MEMORANDUM TO: Mayor and City Council

SUBJECT: Preliminary Background Report
SP-8136-2019: 102 and 104 South Frederick Avenue

Application SP-8136-2019¹ has been filed requesting concept site plan approval for the construction of a new two-story, 5,600 square foot office building. The subject properties are zoned CD (Corridor Development).

Exhibit #33: South (right) and North (left) elevations

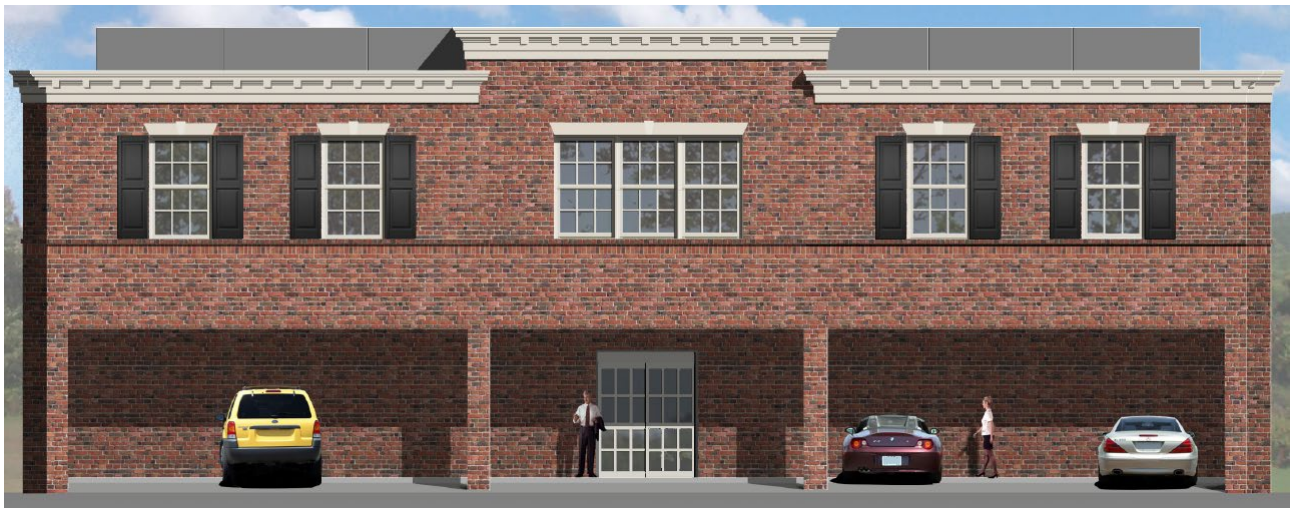
- The three (3) center windows on the rear elevation are not proportionate to the rest of the building. There should be harmony with the architecture.
- The door on the rear elevation should have the same trim color as the windows.

In response to the HDC's comments, the Applicant revised the scale of the three (3) center windows on the rear elevation. By scaling the windows size, the Applicant was able to keep a continuous brick band around the entire building. The Applicant also changed the color of the rear door to match the same color trim of the windows.⁴
